G.O. No. 1064

Sanctioning a ----- of Rs.14,250 towards the cost of
constructing a building for the St. Antony's secondary school,
Tanjore.

The Director of Public Instruction submits, for approval, plans bearing D.P.I.No.238(a) and 238(b) and a detailed estimate of Rs.22,500/- for the construction of a Secondary School building at Tanjore.

The Director of Public Instruction submits for approval 2 drawings bearing D.P.I.No.241(A) and 241(B) and a detailed estimate amounting to Rs.30,000 in connection with a grant-in-aid towards the cost of constructing Saint Antony's Secondary School at Tanjore.

EXTENSION PLAN
OF
TANJORE TOWN

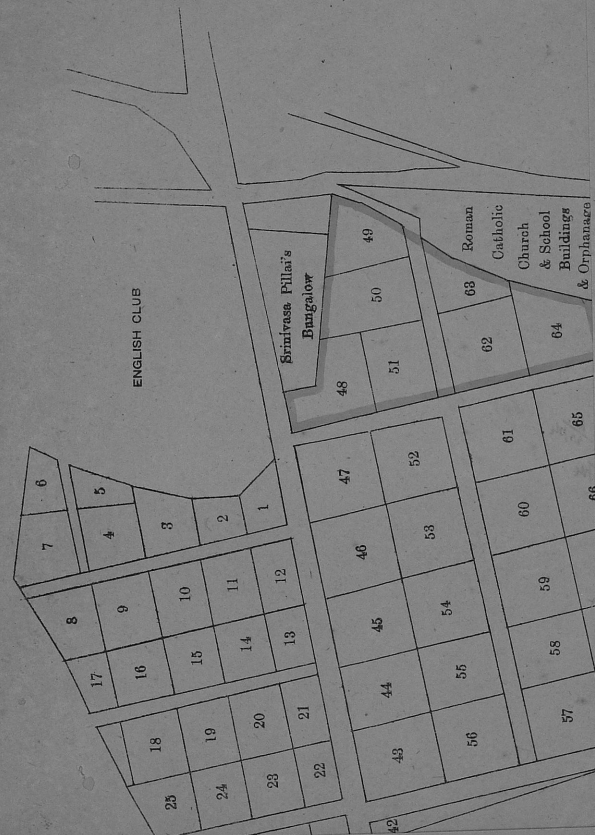
II The blue enclosure is the land the Mission wants ;
64 & part of 62 & 63 it already holds on a lease
for 22 years of which 10 are yet to run.

III The council offers 70-80 Mr. Tressler, as Director
of Industries stipulates for Nos. 48-51.
